Westinghouse
Electric Corporation

NSD-NRC-97-4966
DCP/NRC0722
Docket No.: STN-52-003

ATTENTION: T. R. QUAY
SUBJECT: INFORMAL CORRESPONDENCE

Attachment 1 to Westinghouse Letter NSD-NRC-97-4966

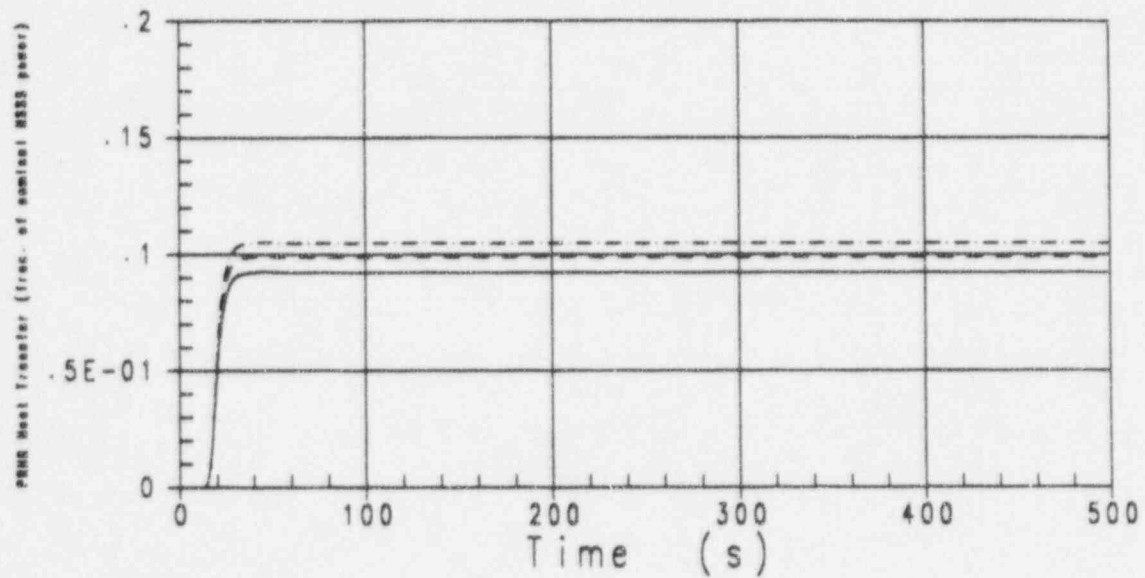
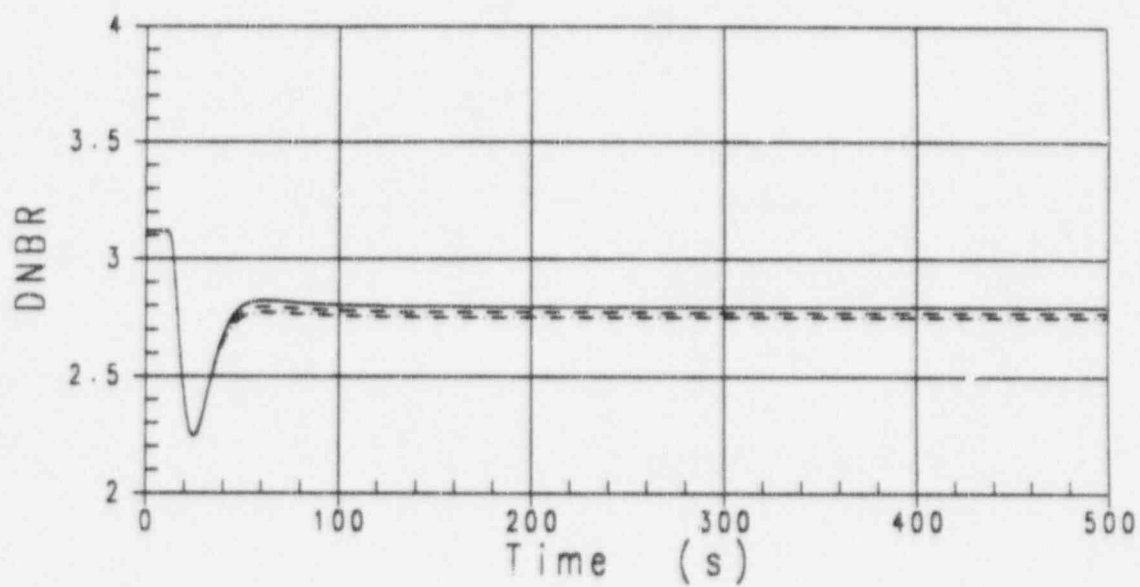
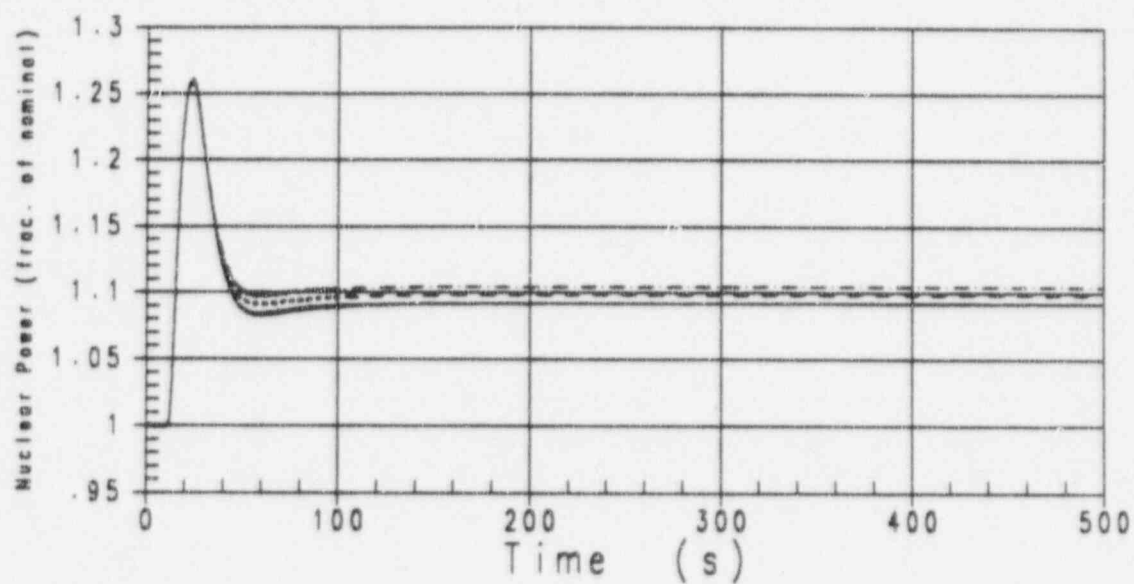
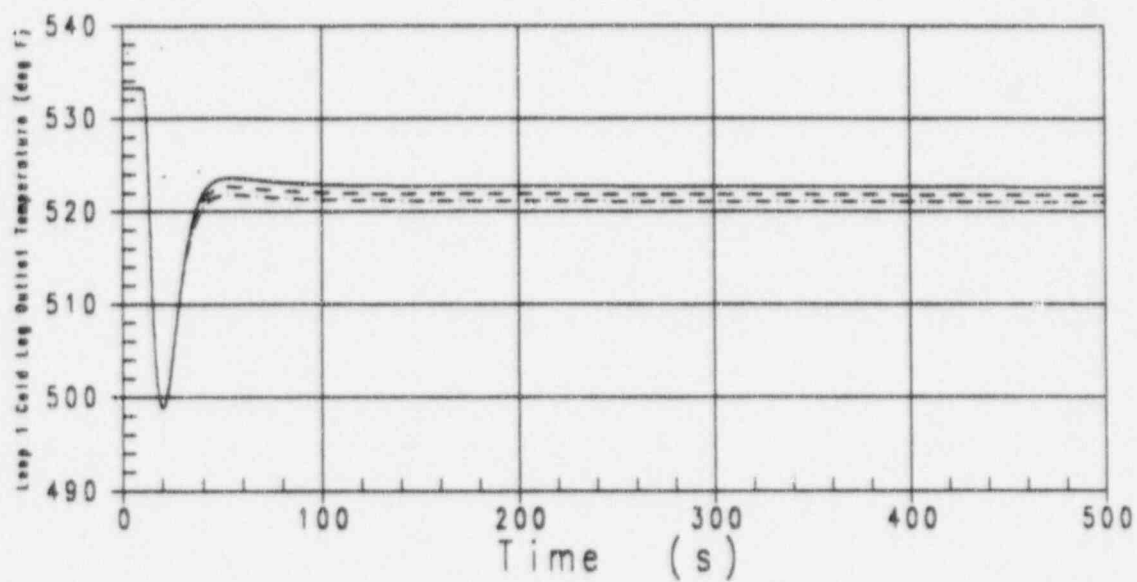
Figures 1 through 4 show the results of the inadvertent operation of the PRHR while at power analysis. Inadvertent operation of the PRHR at power causes an injection of relatively cold water into the reactor coolant system. This produces a reactivity insertion in the presence of a negative moderator temperature coefficient. Since the fluid in the PRHR heat exchanger is initially in equilibrium with the IRWST temperature, the initial flow out of the PRHR is significantly colder than the RCS fluid. Following this initial surge, the PRHR outlet temperature increases and is limited by the cooling capacity of the PRHR. As shown in Figure 3, around 12 seconds there is a large peak in core power due to the initial surge of cold fluid from the PRHR. After the original fluid in the PRHR is purged, the temperature of the fluid exiting the PRHR increases and core power decreases to a value which is in equilibrium with the heat removal rate of the steam generators and the PRHR. For this event the peak core power achieved and the minimum DNBR are dependent on the initial volume of cold fluid in the PRHR and are independent of the magnitude of the PRHR heat transfer. PRHR heat transfer capacity only affects the final equilibrium power. As shown in Figure 1, with the RCPs running and the reactor at power conditions, the PRHR removes approximately 10% of rated plant power. The deviation in overall PRHR heat removal capacity due to the uncertainty in the Rohsenow nucleate boiling correlation is less than $\pm 0.7\%$ of plant rated power.

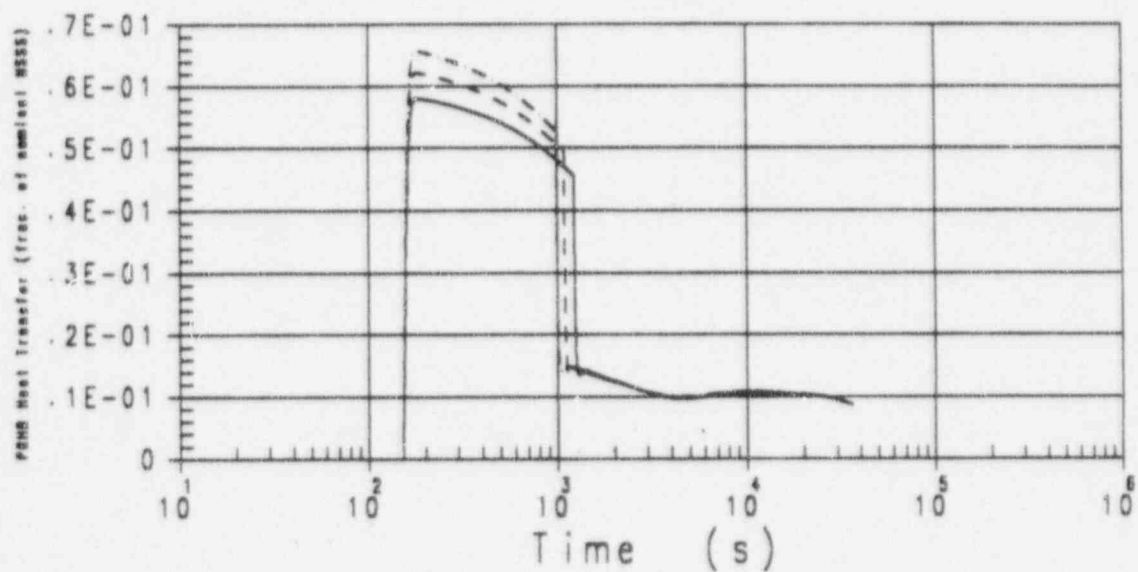
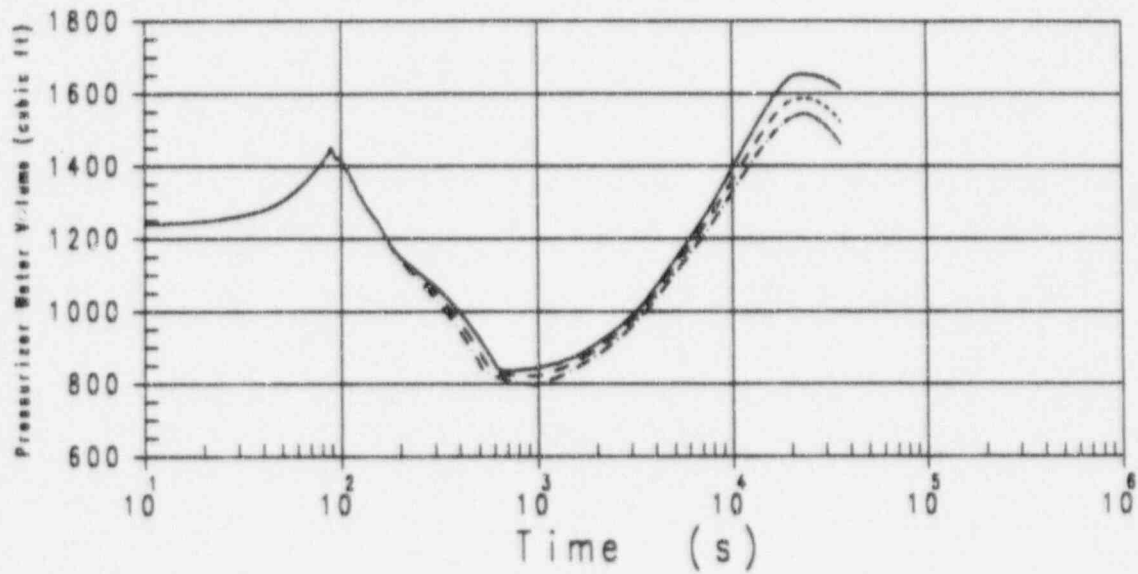
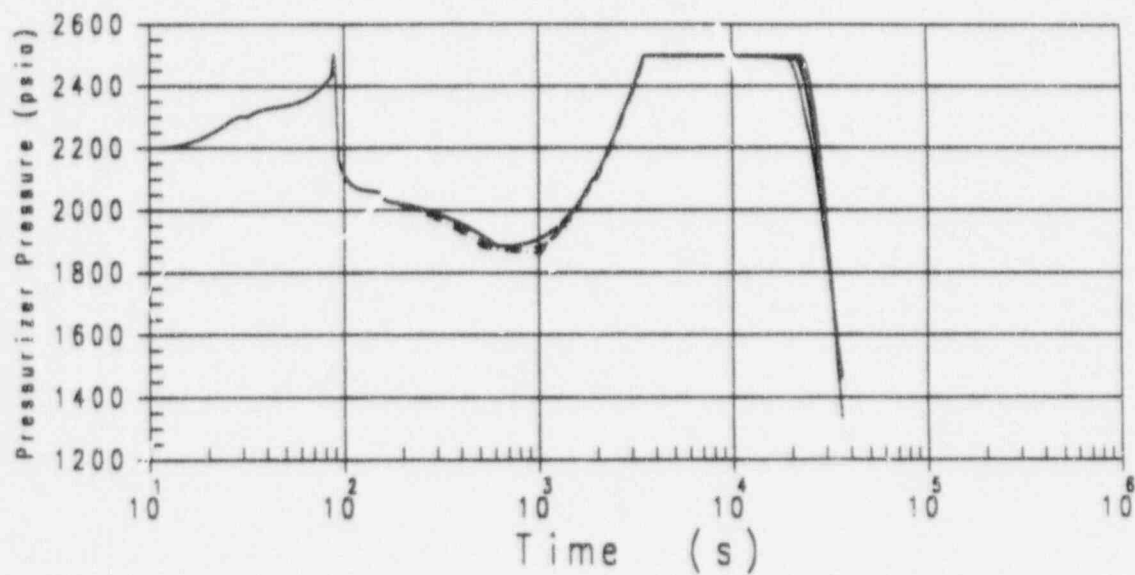
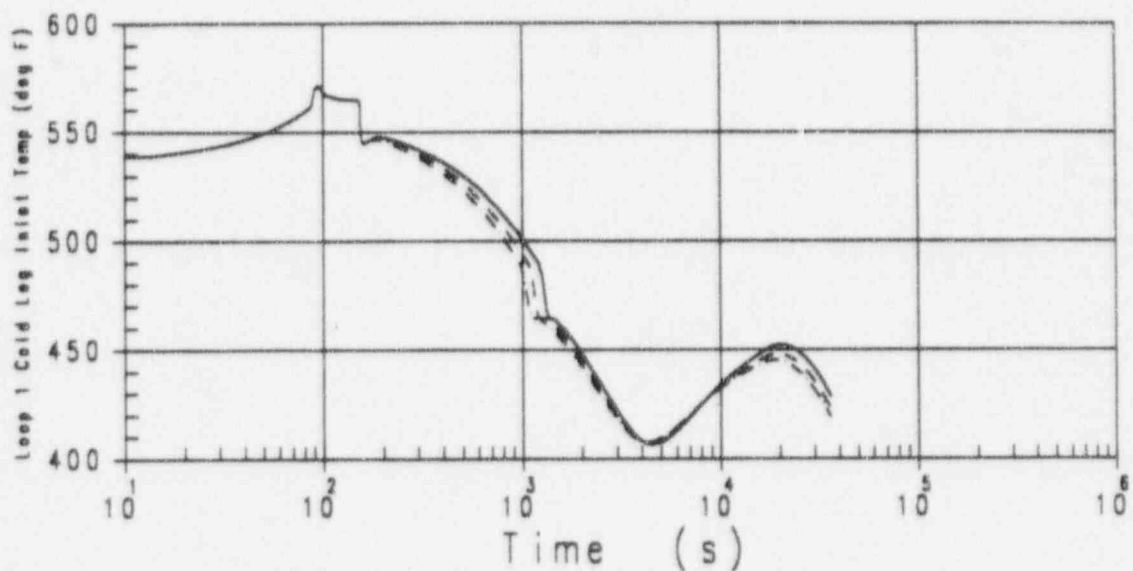
Figures 5 through 8 show the results of a complete loss of normal feedwater analysis using the upper 95 percentile line, the lower 95 percentile line and the nominal fit lines for the Rohsenow correlation. The PRHR total heat flux is shown in Figure 5. The reactor coolant pumps are running until just after 1000 seconds. While the RCPs are running, PRHR heat transfer is ~ 6 % of rated plant power. After the reactor coolant pumps are tripped, PRHR heat transfer drops to ~ 1 % of rated plant power. During the period where pumps are running the, uncertainty in the boiling heat transfer coefficient causes a total deviation of less than $\pm 0.5\%$ of rated plant power. After the RCPs trip the difference in overall PRHR heat transfer is negligible. From Figure 6, the deviation in peak pressurizer water volume is $+67 \text{ ft}^3$ to -42 ft^3 . The peak pressurizer water volume occurs in all of the three cases at least 5 hours after the start of the transient. Figure 7 shows that there is no increase in peak RCS pressure due to the correlation uncertainty.
